**SUBJECT:** R.E. Ginna Nuclear Power Plant  
Docket No. 50-244

**Supplemental Response to Requests for Additional Information Regarding  
Topics Described by Letters Dated August 24, 2005 and October 28, 2005**

ATTACHMENT 2  
RESPONSES TO NRC RAIs 2, 3, 5 REGARDING POST-LOCA LONG-TERM COOLING  
OCTOBER 28, 2005

ATTACHMENT 3  
RESPONSES TO NRC RAIs REGARDING LOCA ANALYSES  
AUGUST 24, 2005

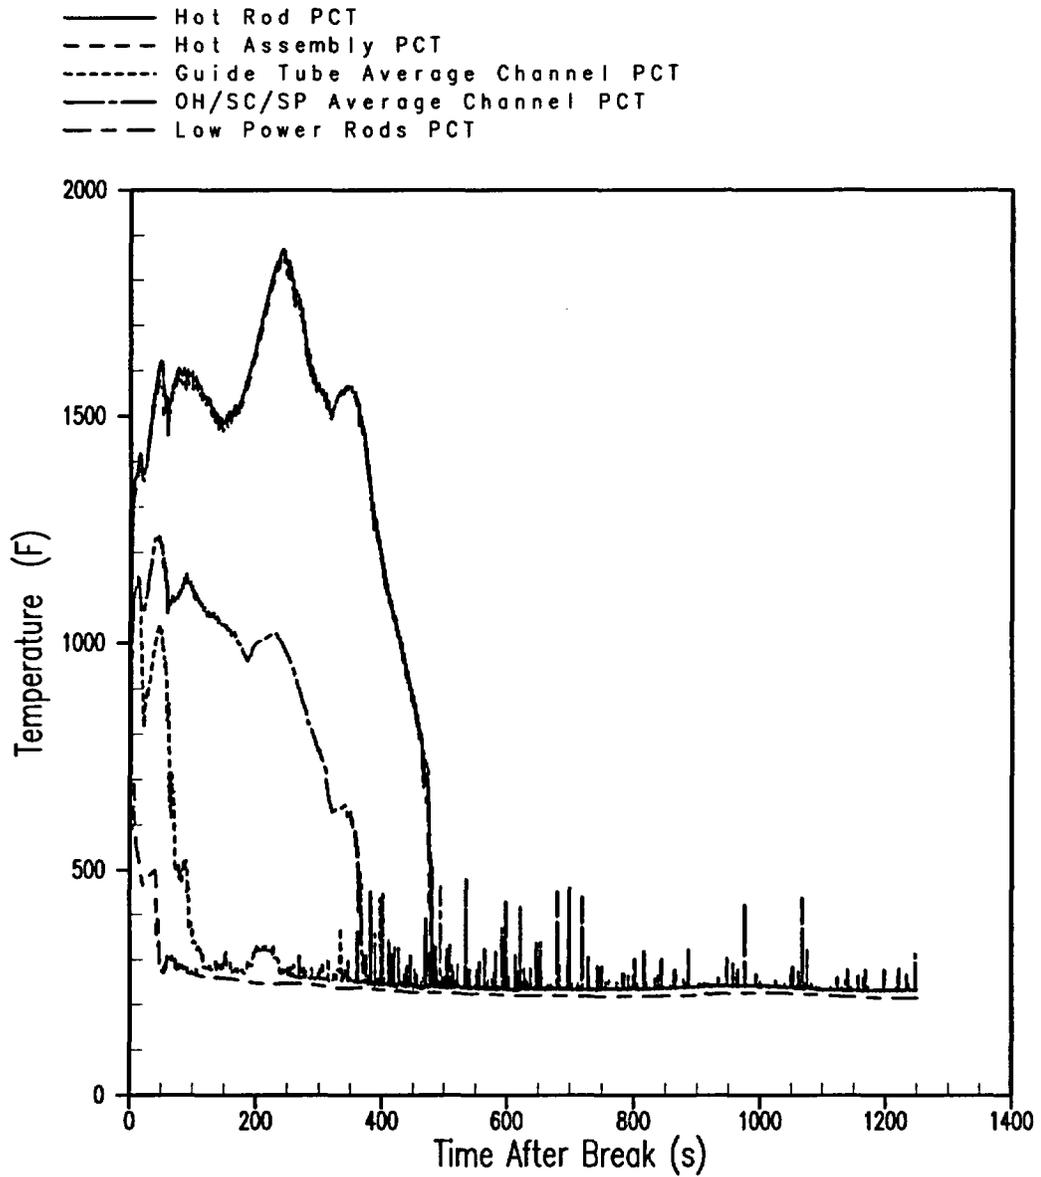
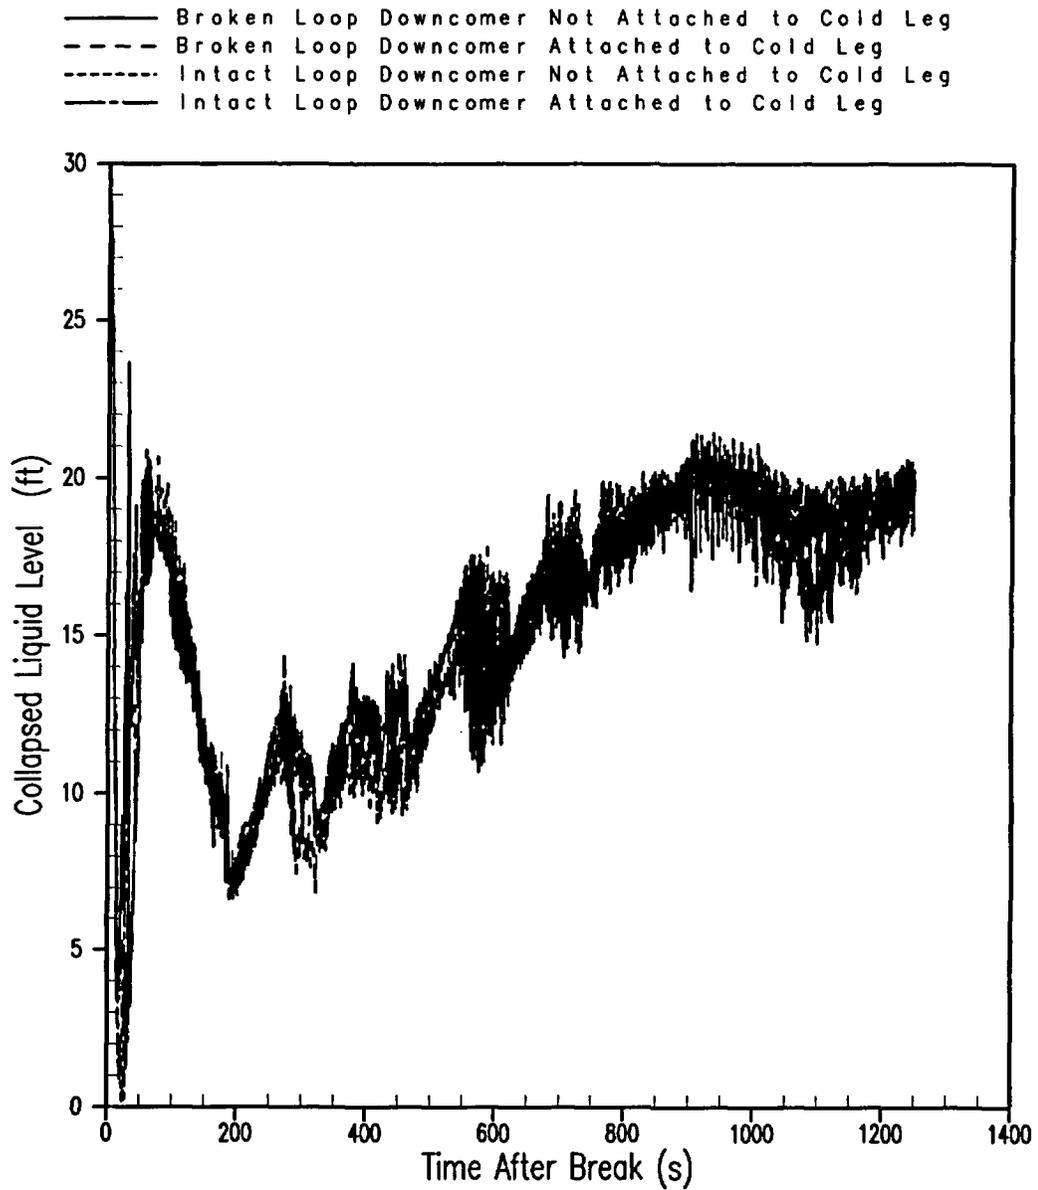
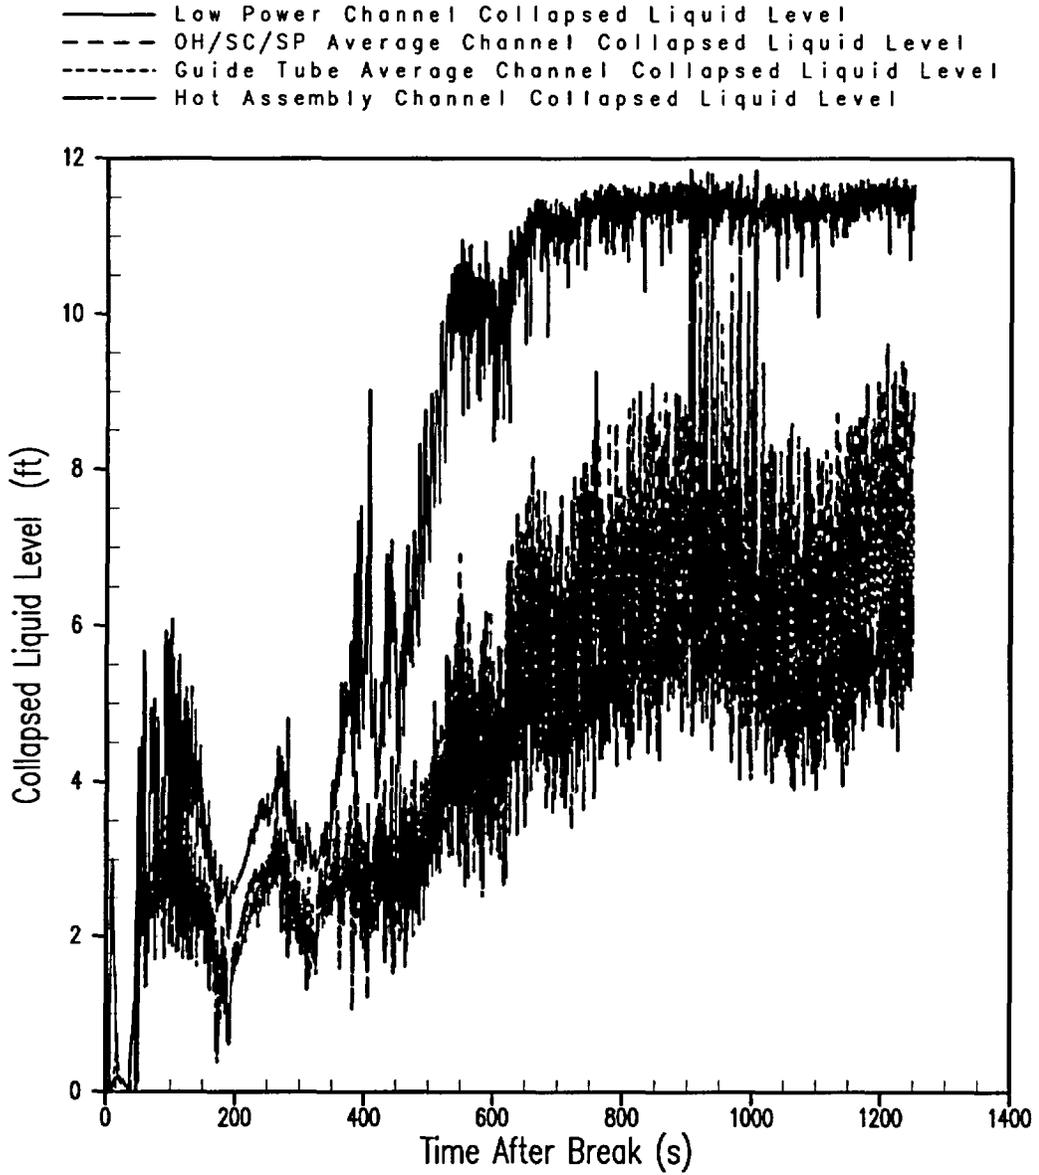
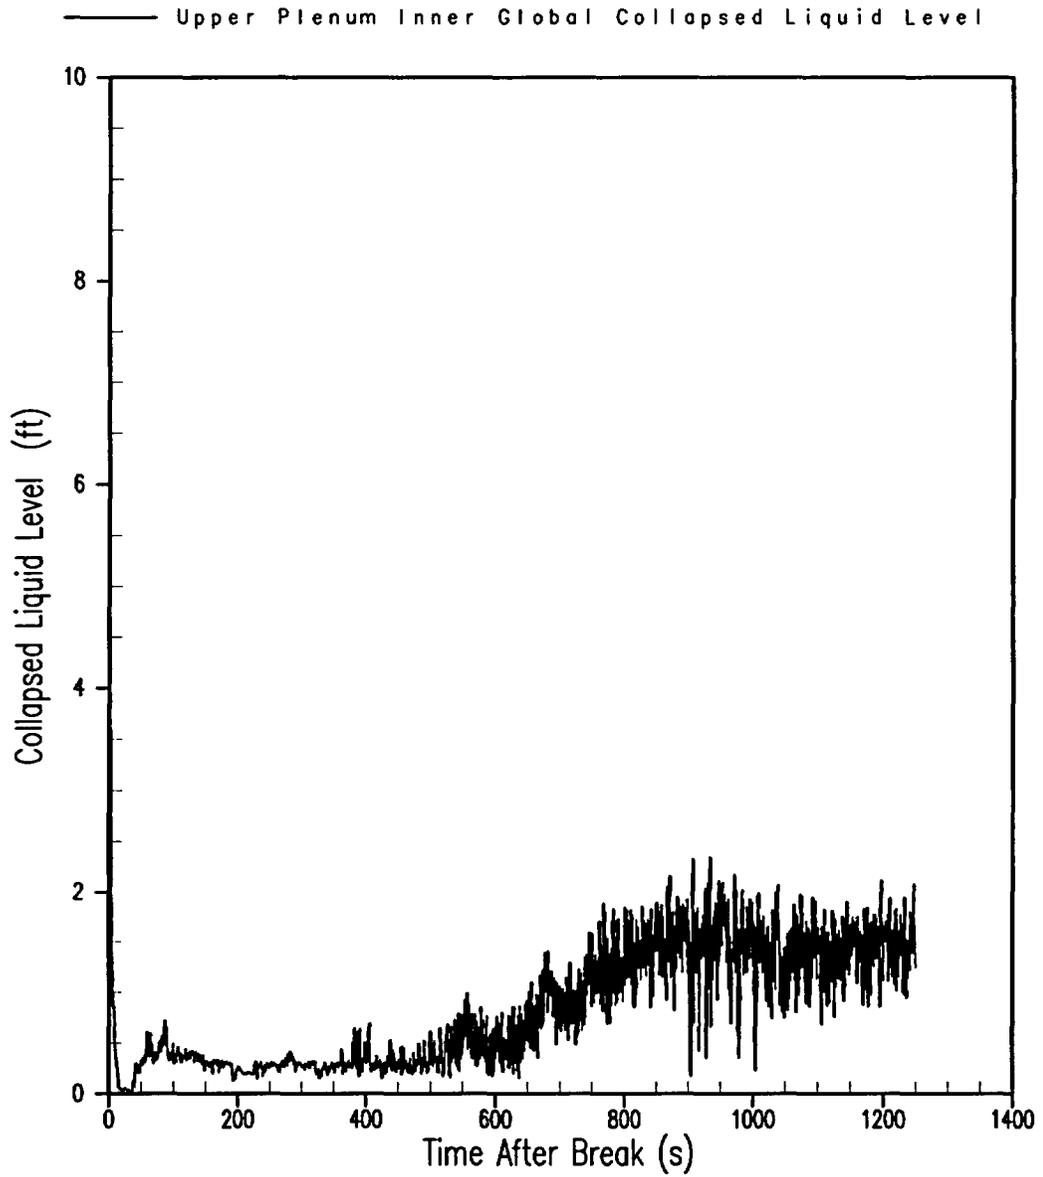
Provide the complete analysis results including all of the key major response parameters. Also, did the analysis include downcomer boiling effects and what was the worst single failure if downcomer boiling occurs? What containment pressure was assumed?

In order to demonstrate stable and sustained quench, the WCOBRA/TRAC calculation time for the limiting PCT case was extended. Figure 2.1 shows the peak cladding temperatures for the five rods modeled in WCOBRA/TRAC. This figure indicates that quench occurs at approximately 50 seconds for the low power rod, 100 seconds for the core average rods under guide tubes, 375 seconds for the balance of the core average rods, and 500 seconds for the hot rod and hot assembly average rod. Once quench is predicted to occur, the rod temperatures remain slightly above the fluid saturation temperature for the remainder of the simulation. Figure 2.2 is a plot of the collapsed liquid level in the four downcomer channels and shows steady behavior, with the level in each quadrant remaining near the bottom of the cold leg. Figure 2.3 shows the collapsed liquid level in the four core channels and indicates a gradual increase in the core liquid inventory. This is consistent with the expected result based on the removal of the initial core stored energy and the gradual reduction in decay heat. Figure 2.4 shows the collapsed liquid level in the upper plenum and indicates that there is a pool of water that has accumulated on the upper core plate. Figure 2.5 is a plot of the vessel fluid inventory, which shows a trend of increasing vessel inventory with time after 300 seconds. This indicates that the increase in inventory due to the pumped safety injection is more than offsetting the loss of inventory through the break. Based on these results, it is concluded that stable and sustained quench has been established for the R. E. Ginna Large Break LOCA analysis.
